## CITY OF ALBUQUERQUE

Site: Beehive Montano

Re: Drainage Ordinance (14-5-2-1) Violations for Erosion and Sediment Control

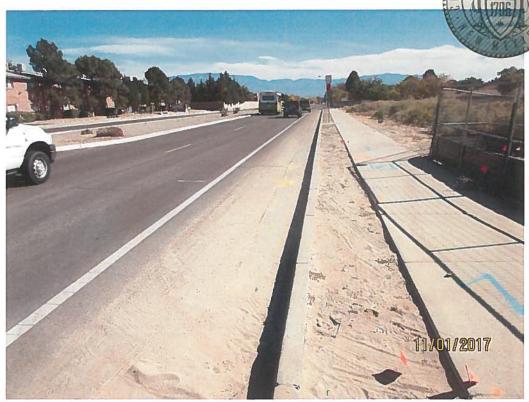
Dirt ramp in street, grade too high between sidewalk and back of curb and no track-out pad.

1. Remove dirt ramp from Montano Rd. Usually lumber in the gutter or cold mix can be used to help gain access to a site over the curb. In this case, since Montano is a fairly high speed and busy road, the recommendation is to cut the curb. Curb cut permits can be obtained at Plaza del Sol 8<sup>th</sup> floor, Construction Services.

3. Install a Stabilized Construction Entrance (track-out pad) per approved plan.

4. Lower the grade between the sidewalk and back of curb in the vicinity of the dirt ramp to approximately 2 inches below the top of curb.
